Re: Response to Application Completeness Determination for FGE Power, LLC  
Greenhouse Gas Prevention of Significant Deterioration Permit  
FGE Texas Project: Westbrook, Mitchell County, Texas

**FGE Power's Responses to Mr. Thomas Diggs's Letter dated December 23, 2013**

**Attachment 4 –  
Revised Process Flow Diagrams**

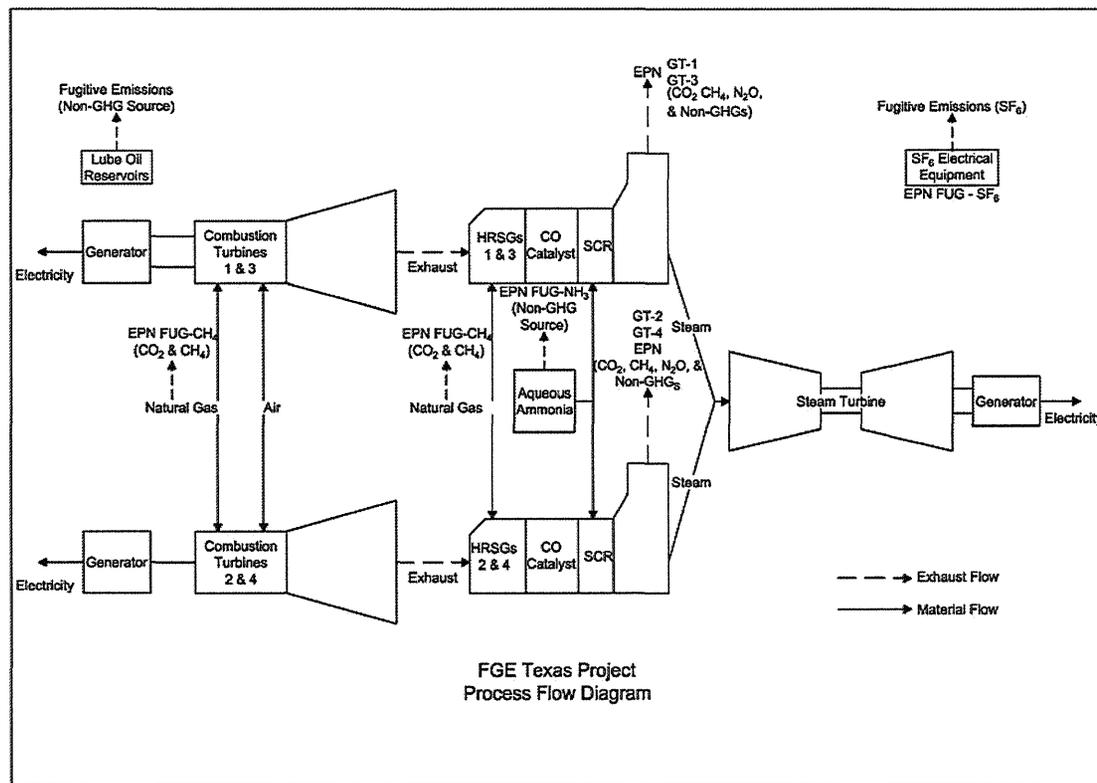
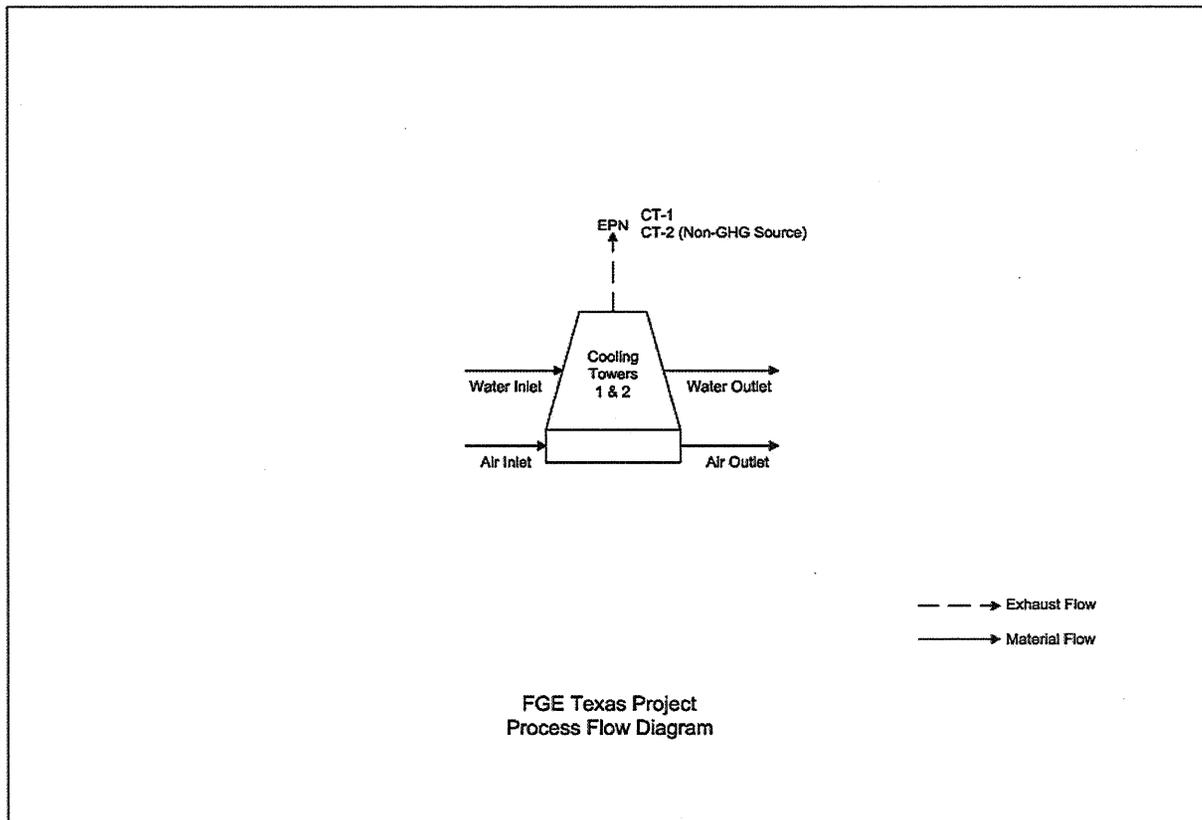
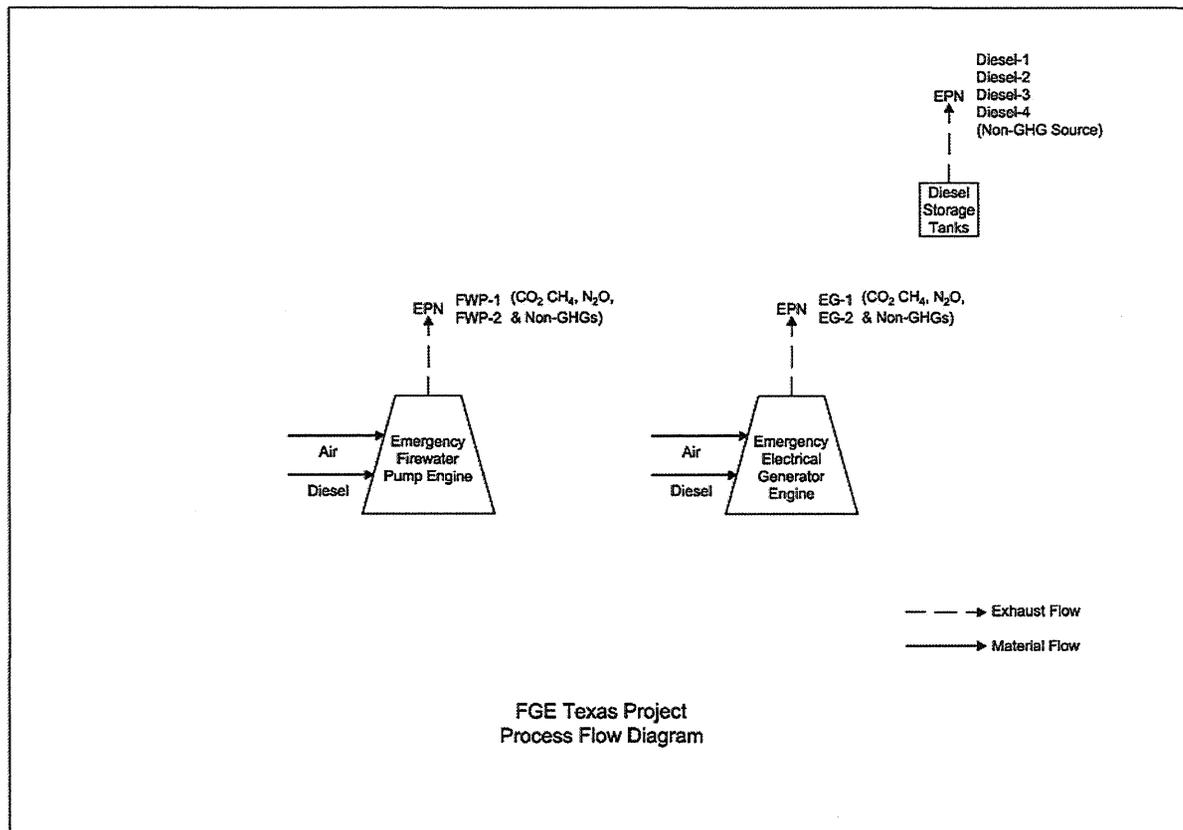
4. Beginning on page 35 of the permit application, a list and brief summary is provided for the other equipment (i.e., condenser cooling tower, four diesel storage tanks, lube oil

reservoirs and ammonia storage and unloading) proposed for the project. Although it is stated that this equipment is not a GHG emission source, it should be represented on the process flow diagram to depict what the project will entail to for a complete permit record. In addition to identifying the emission source with the associated EPN, please label as a non-GHG source for clarity. Also, please show on the process flow diagram the emission sources for fugitives (CH<sub>4</sub>, CO<sub>2</sub>, and SF<sub>6</sub>, fire pump engine, emergency electrical generator engine.)

Revised process flow diagrams, which include all proposed equipment, including fugitive emission sources, associated with the FGE Texas Project are provided as Attachment 4.
